Arlington Conservation Commission

DEP #091-0375: Notice of Intent: 26 Dudley Street.

From: Geilen, Alicia (DEP) <Alicia.Geilen@mass.gov>
Sent: Tuesday, November 25, 2025 4:27 PM
To: Richard Kirby
Cc: Nicole Ferrara; David Morgan; Jackie Anderson
Subject: RE: MassDEP NOI File Number 26 Dudley St., Arlington

SITE PLAN
26 DUDLEY STREET
IN
ARLINGTON, MASSACHUSETTS

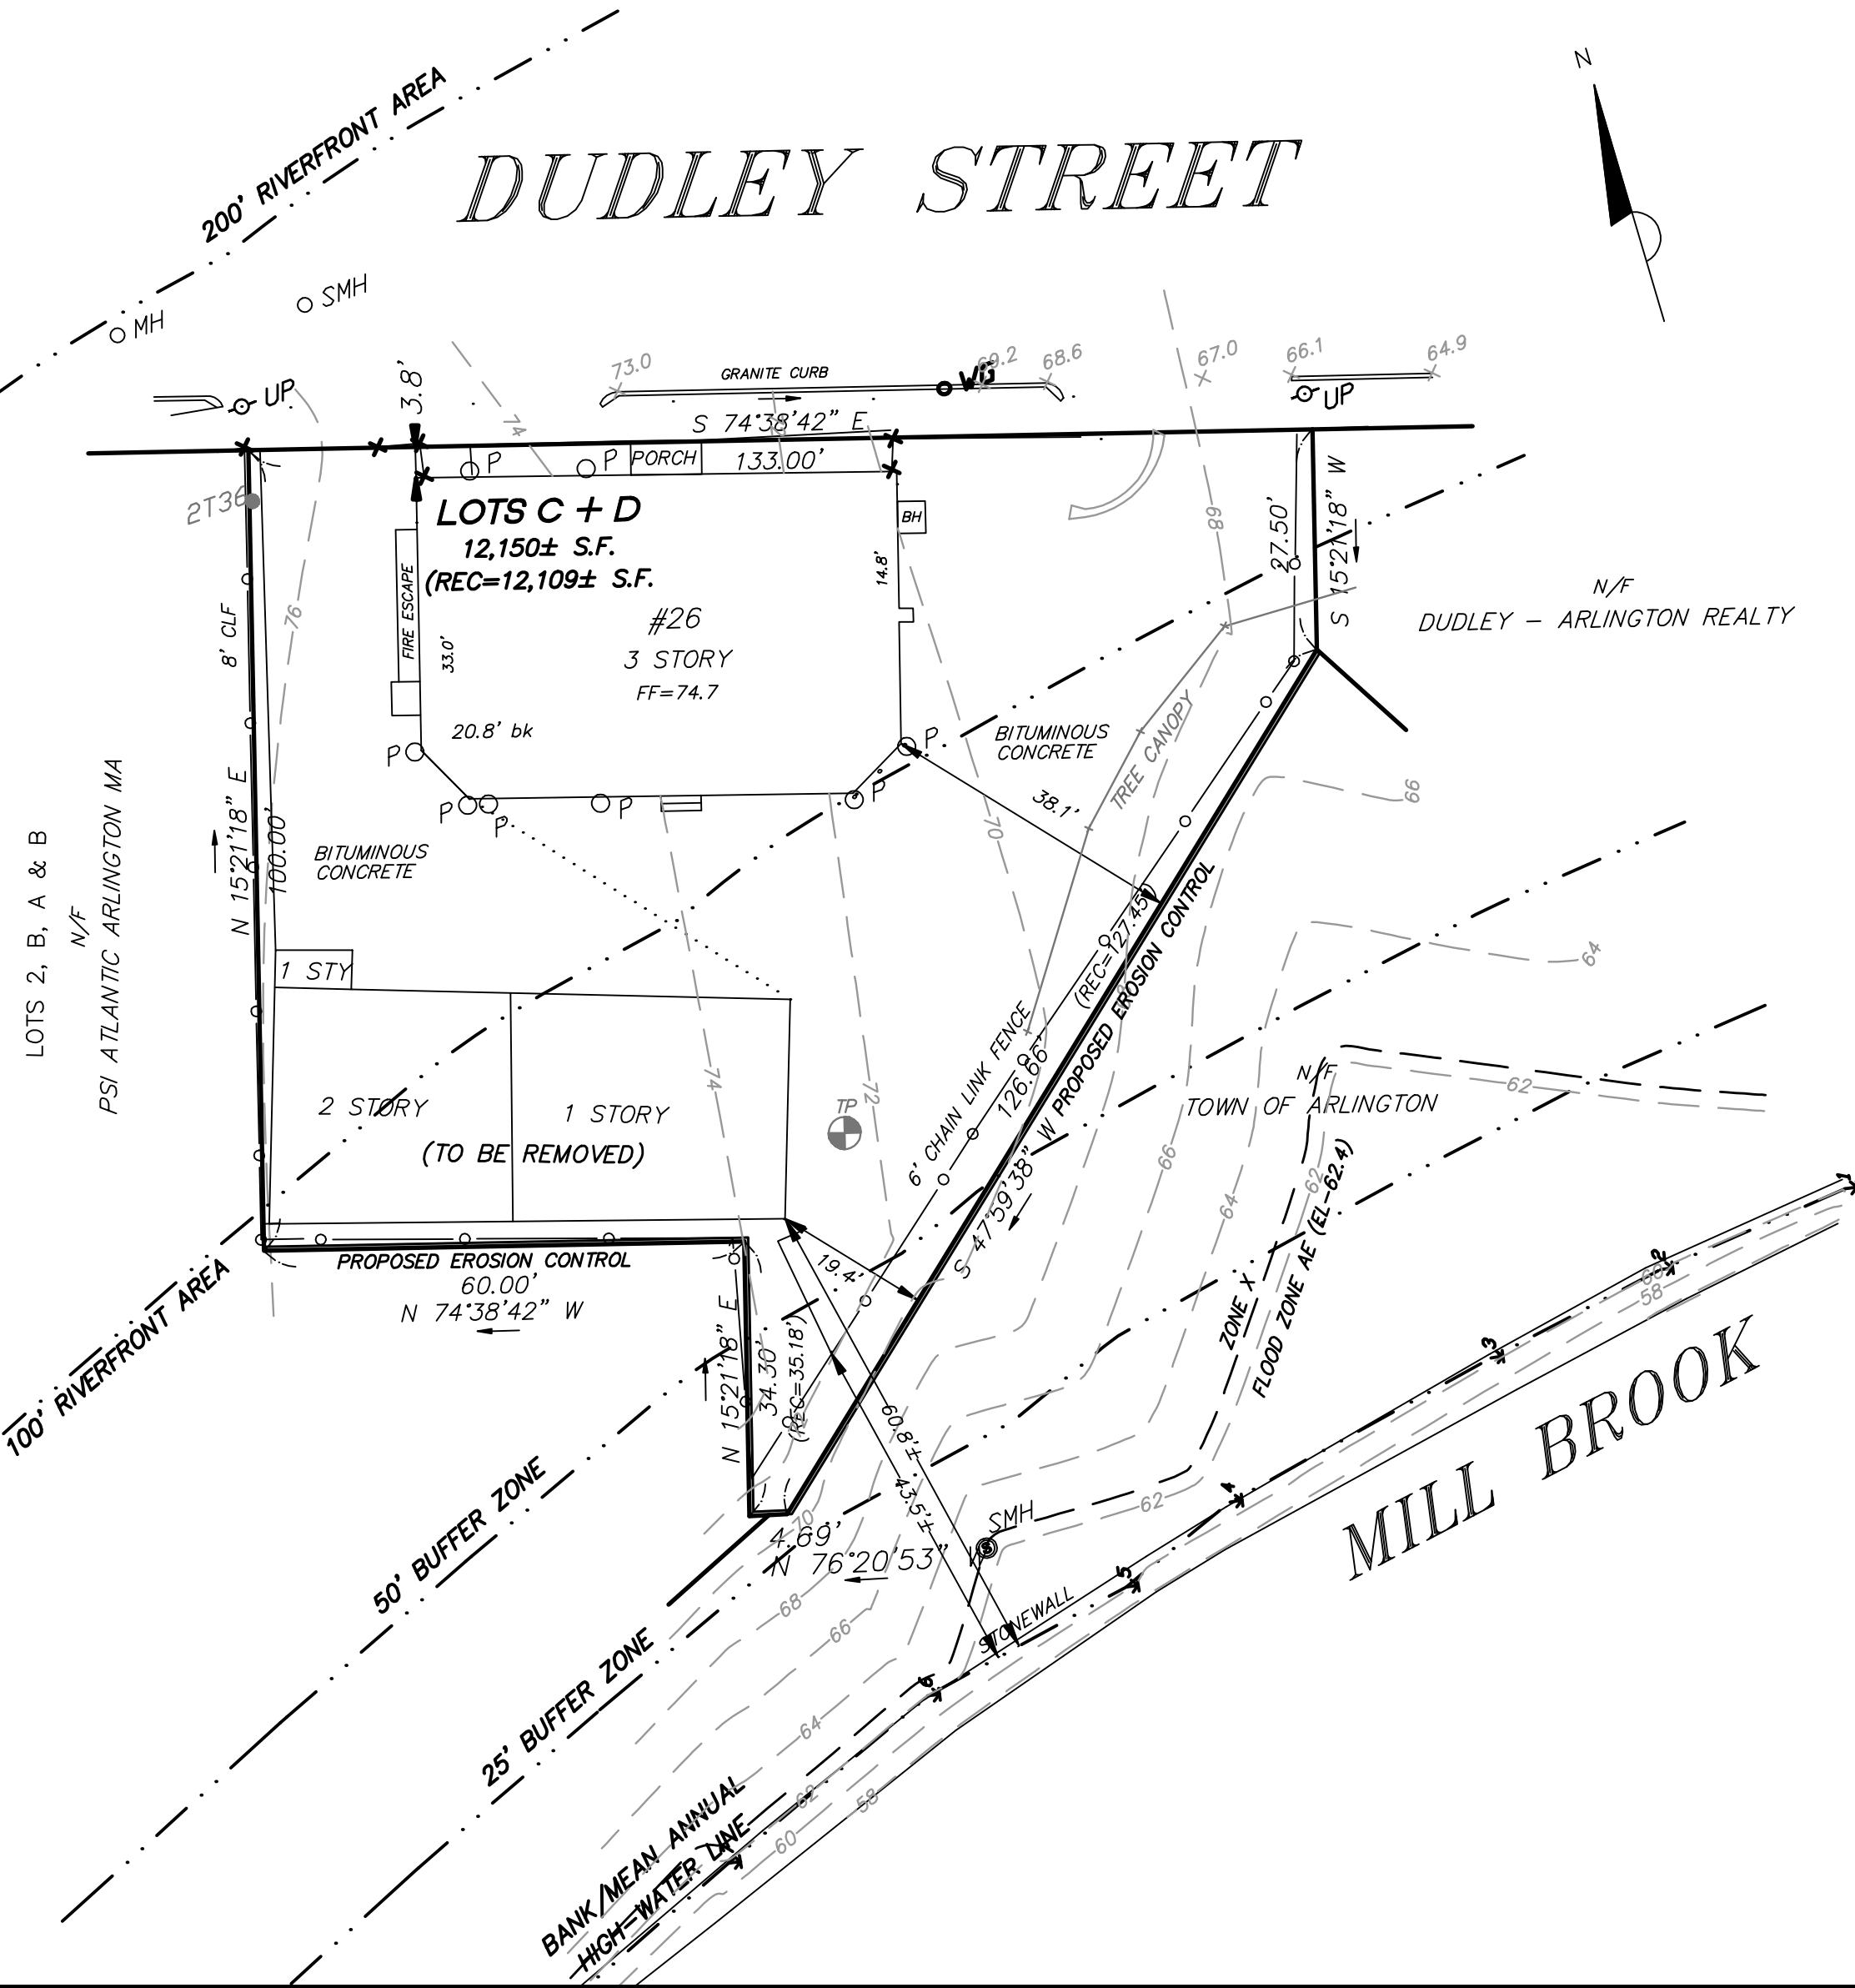
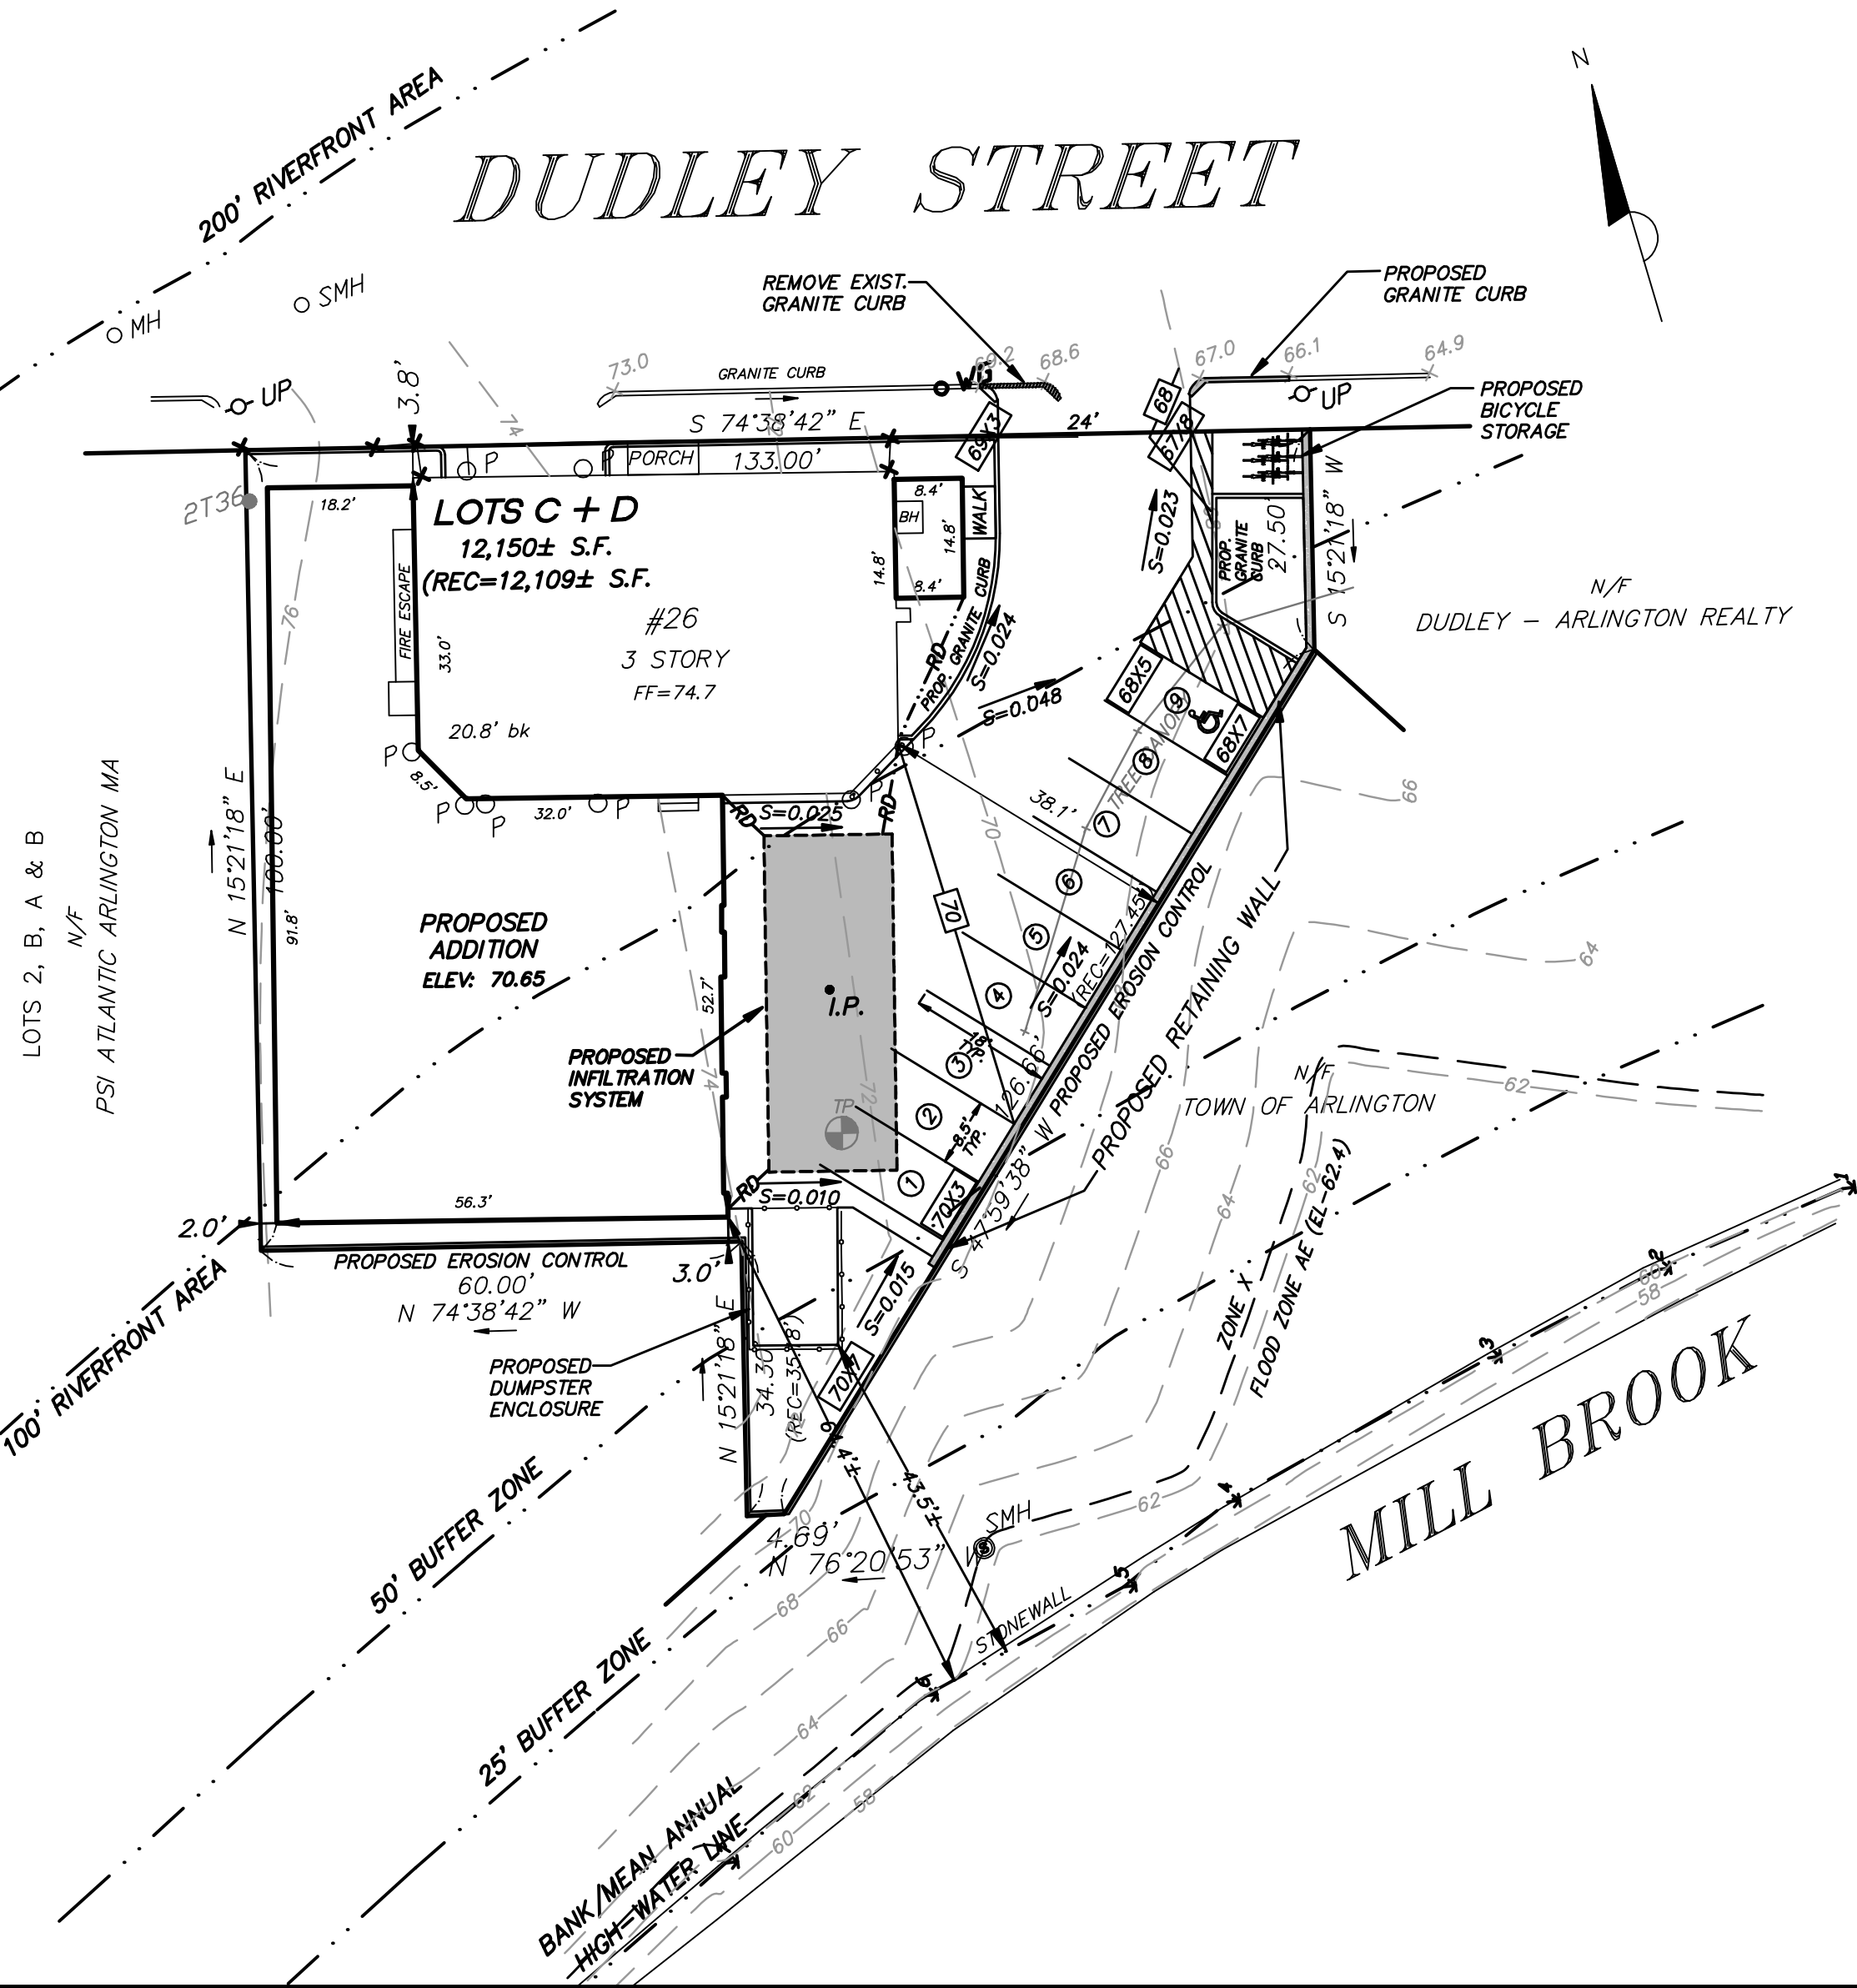
Project does not appear to meet 10.58(5) as proposed. A plan that more clearly indicator exisiting degraded and existing non-degraded areas is needed.

10.58(5)(a) - Project must include an improvement over existing conditions of the capacity of the riverfront area to protect the interests of the WPA. A reduction of 35 sf of impervious surface spread across the site does not provide a meaningful improvement. Mandatory stormwater management does not count as an improvement, because 10.58(a) is a stand-alone requirement, also discussed in 10.58(5).

10.58(5)(b) & 10.05(6)(k) - (q): A peer review of the stormwater design is recommended. No map provided to show different edrainage areas.

The infiltration unit appears to only remove 25% TSS not 80%, and requires pretreatment. The Commission should request additional information on how 80% TSS removal will be achived.
